Fire Station 7

Fire Station 7 is a single story structure with an on-grade entry. There are currently no features of accessibility provided within the building.

Accessibility Review

Photo 1: Modify to eliminate the 1" rise at the main entry.

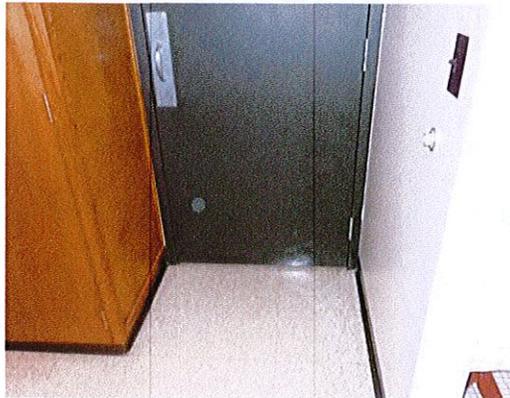
| Location JQP # / Item # | Solution / Comments | Qty | Unit Cost | Total Cost | Priority | Estimated Compl. Date | Person Responsible | Actual Compl. Date | Actual Cost |
|----------------------------|---|-----|-----------|---------------------------|--------------|--------------------------|-----------------------|--------------------------|----------------|
| 12H 15681 | Bevel / replace / reset threshold so there is no abrupt rise greater than 1/2" or slope greater than 1:2. ICC / ANSI 404.2.4 <i>Currently 1" rise. Photo 1.</i> | 1 | \$200 | \$200 | 2 | | | | |

Photo 4: View of women's locker room. Replace the existing grab bar contraption with compliant grab bars.

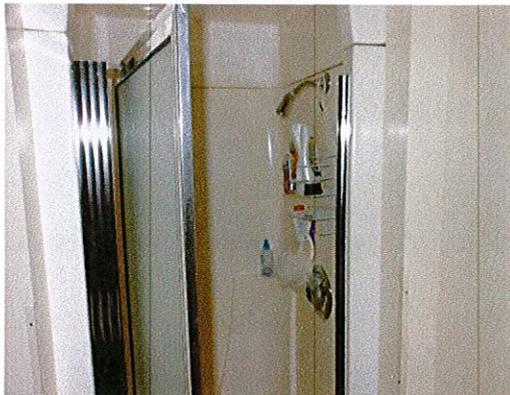
| Location JQP # / Item # | Solution / Comments | Qty | Unit Cost | Total Cost | Priority | Estimated Compl. Date | Person Responsible | Actual Compl. Date | Actual Cost |
|----------------------------|---|-----|-----------|---------------------------|----------------|--------------------------|-----------------------|--------------------------|----------------|
| 22K6 (MN) 15688 | Remove the existing grab bar configuration and replace with a compliant grab bar configuration. MN 1341 604.5.1 ANSI 604.5.2 <i>Photo 4.</i> | 1 | \$400 | \$400 | 3 | | | | |
